Product / Process Change Notification (PCN)

PCN #: PCN_IndHCF_20200302

Affected Series: WE-HCF-2920; 74437429203xxx;
74437529203xxx

DESCRIPTION AND PURPOSE OF CHANGE:

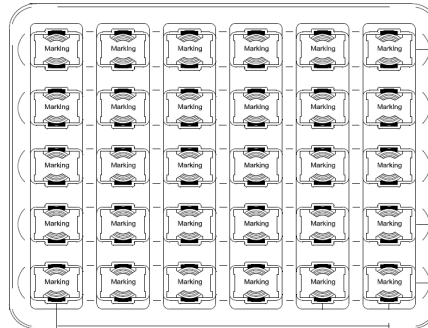
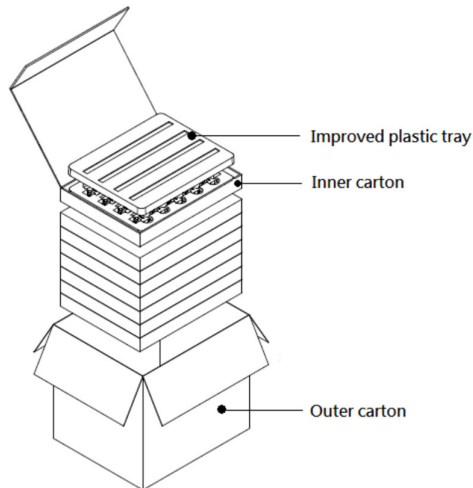
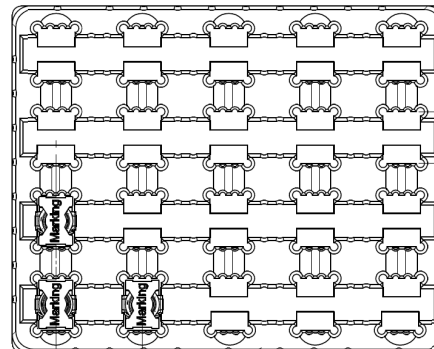
To improve the handling and transportation safety, Würth Elektronik will change the packaging method of HCF 2920 series.

DETAIL OF CHANGE:

Unit	New Packaging	Old Packaging
Carton Packaging Quantity (CPQ)	pcs	160	270
Standard Packaging Quantity (SPQ)	pcs	20	30
Number of plastic trays	pcs	8	9
Plastic tray dimensions	mm	245 x 195 x 23	245 x 195 x 22
Number of inner carton boxes	pcs	8	1
Inner carton dimension	mm	265 x 205 x 30	260 x 210 x 235
Outer carton box dimensions	mm	275 x 232 x 255	275 x 232 x 255
Foam protection		No	Yes
